Mitigation Plan  
Banner Branch Mitigation Project  
Stokes County, North Carolina  
FINAL VERSION

NCDEQ DMS Project Identification # 100080  
NCDEQ DMS Contract # 7610 and # 7701  
Roanoke River Basin (Cataloging Unit 03010103)  
USACE Action ID Number: SAW-2018-01760  
Contracted Under RFP # 16-007405  
DWR Project # 20181154

Re: NCIRT Review and USACE Approval of the NCDMS Banner Branch Mitigation Site /  
Stokes Co./ SAW-2018-01760/ NCDMS Project # 100080

**SUBJECT:** Banner Branch Mitigation Site - NCIRT Comments during 30-day Mitigation Plan Review

SHEET NUMBER  
**23**

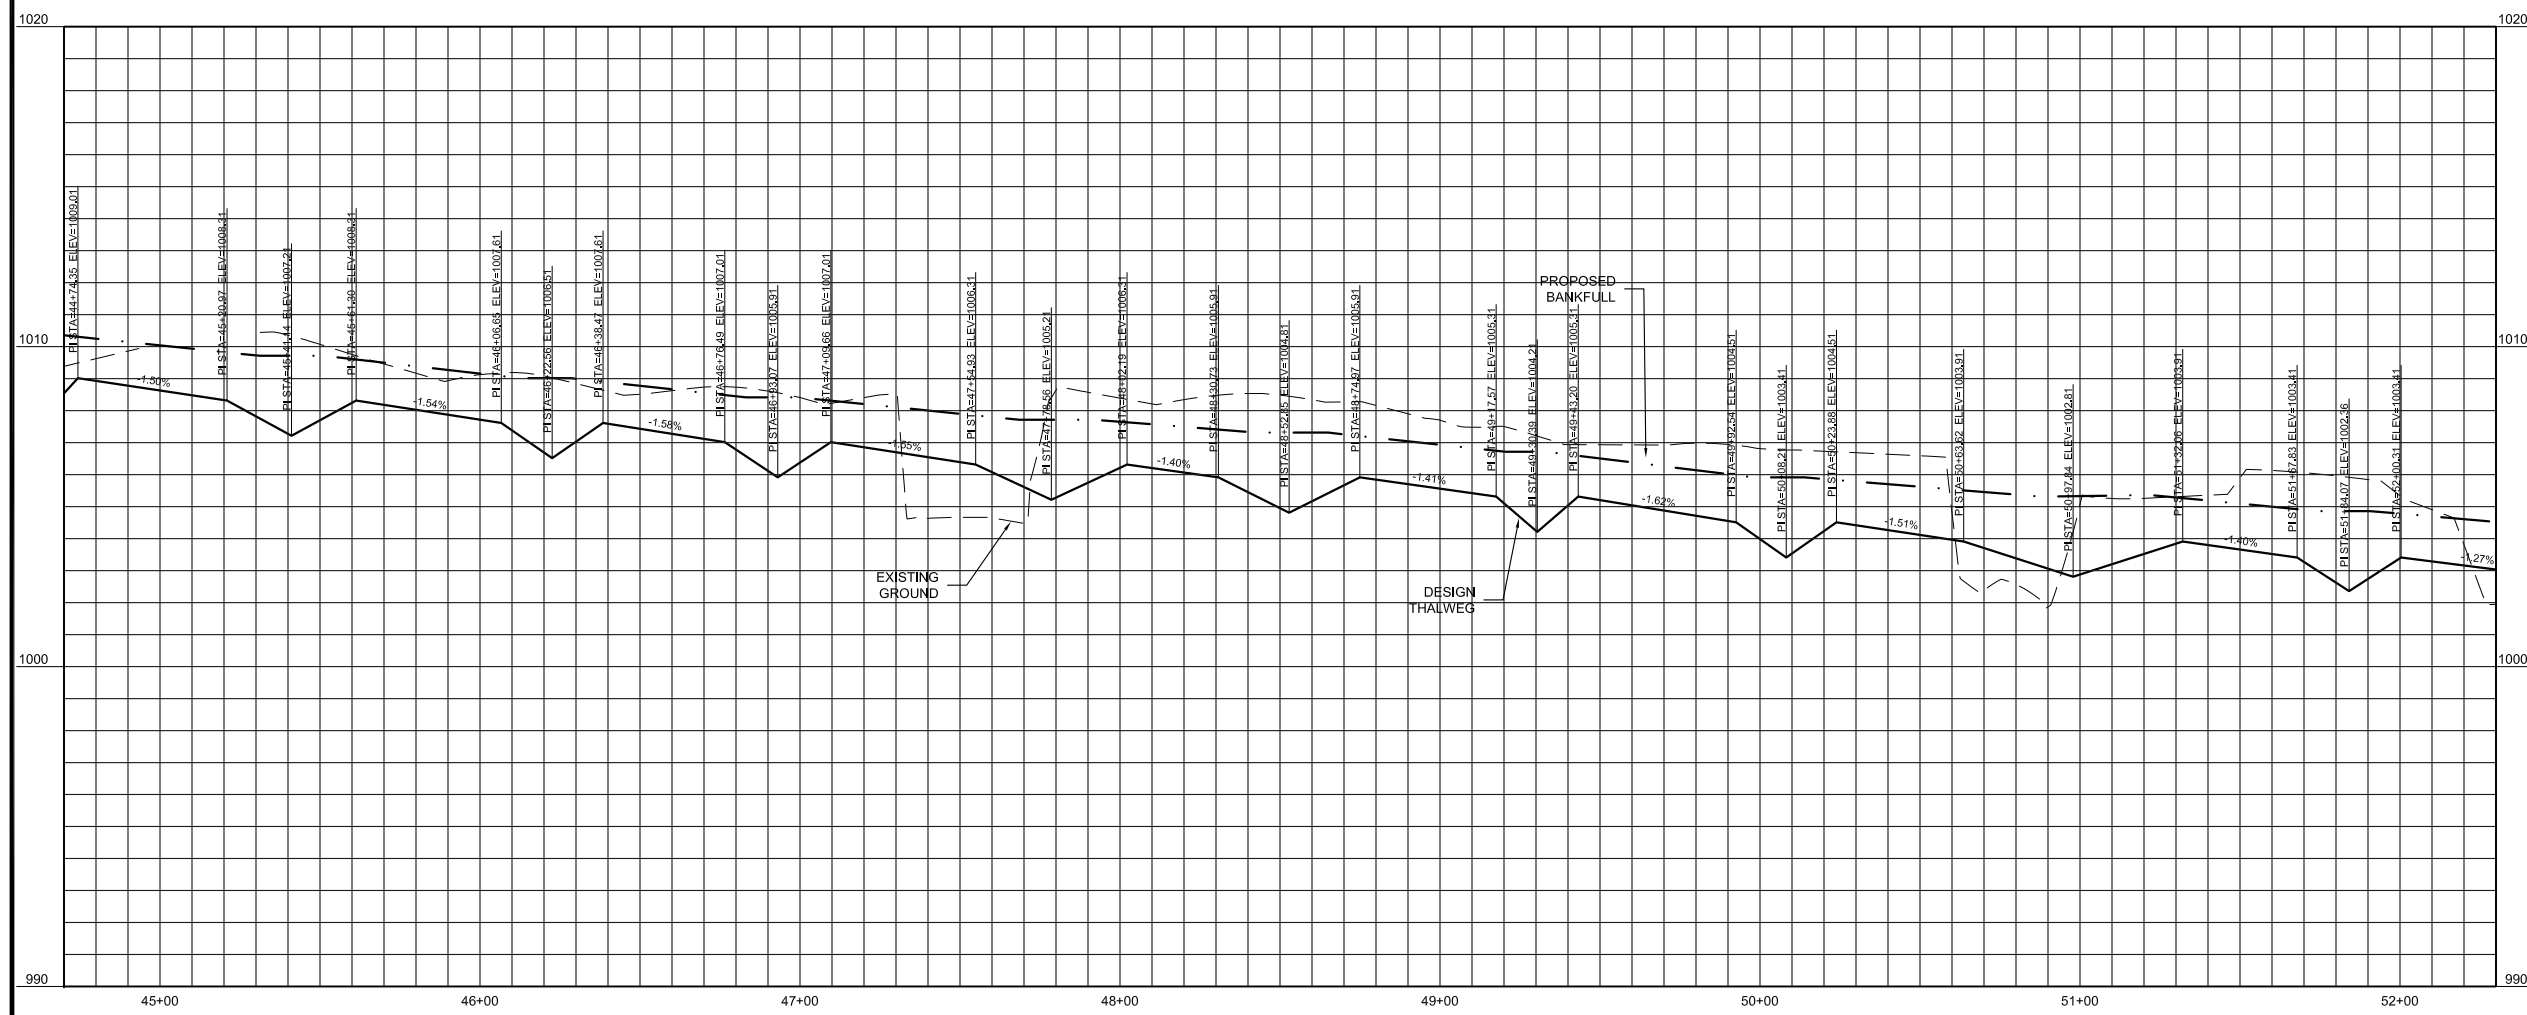
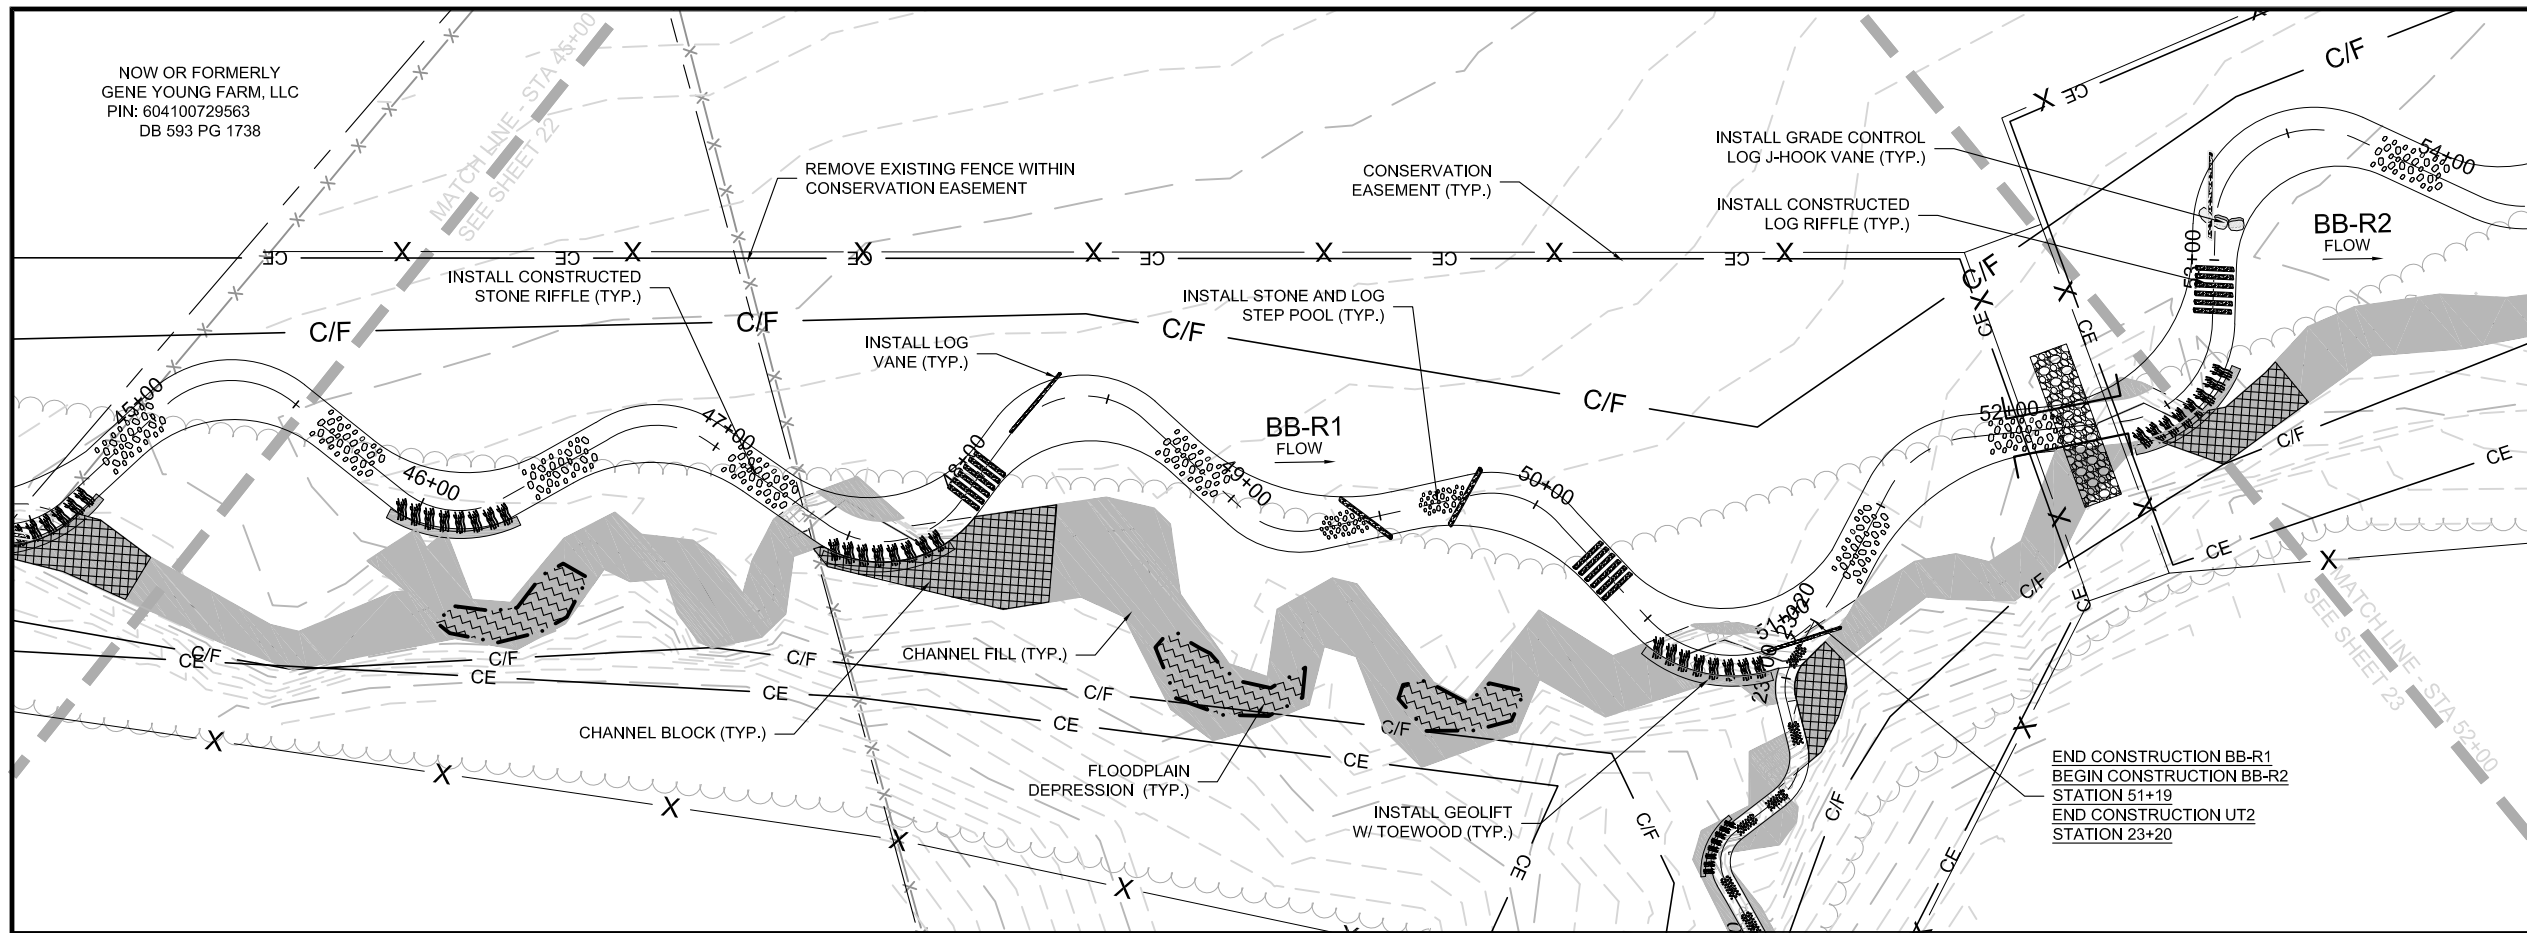
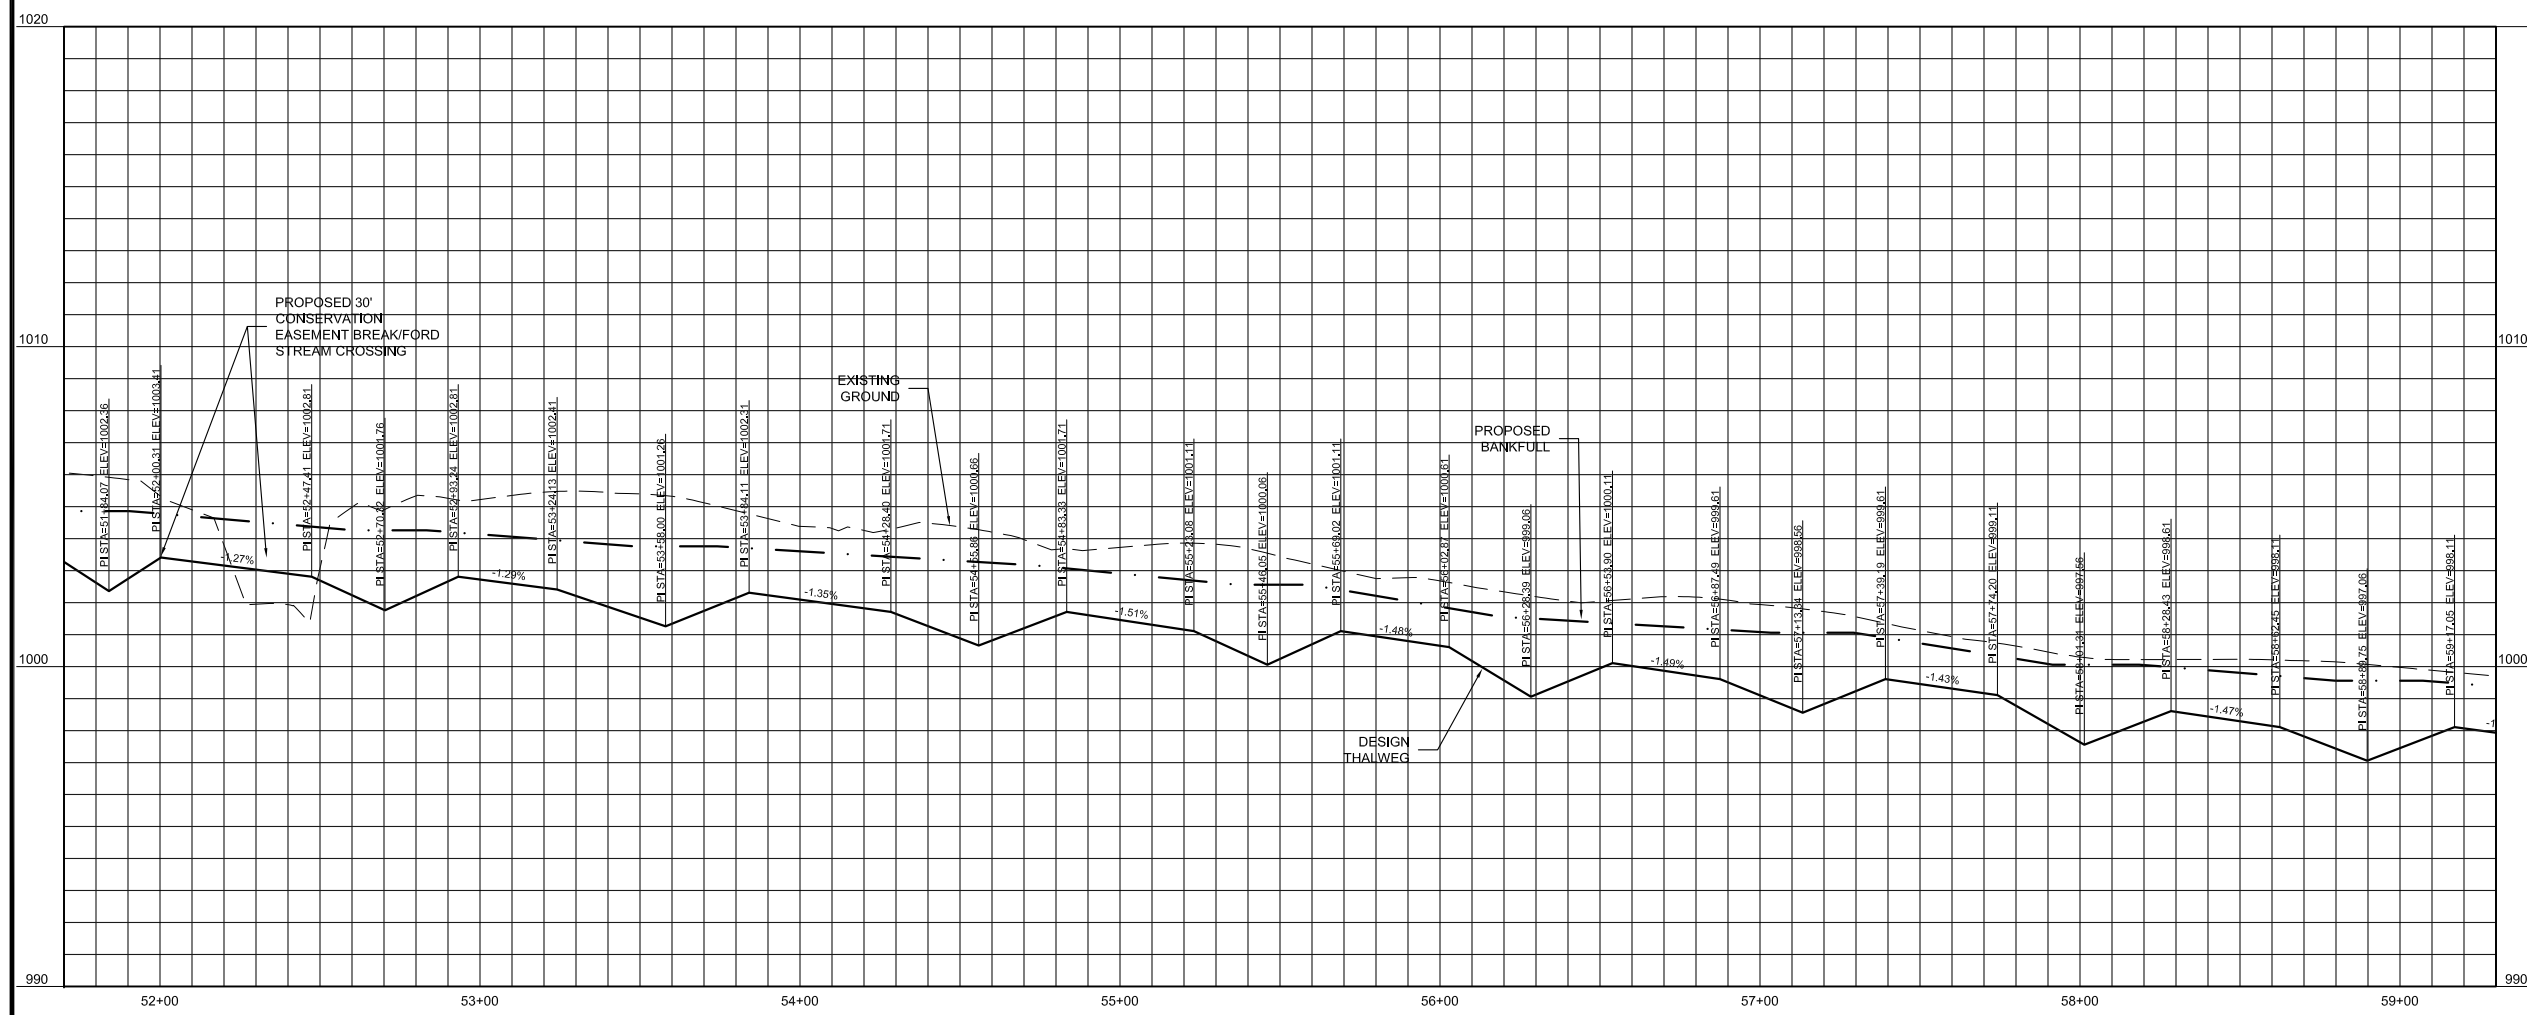
21. Sheet 3 – DWR recommends that benches be at least two times bankfull width for C type stream restoration.
22. Sheets 14, 23 & 33 – Please callout stream crossings/easement breaks on the profile views.

**22. Sheets 14, 23 & 33 – Please callout stream crossings/easement breaks on the profile views.** Response: Stream crossings/easement breaks have been noted in the profile views.
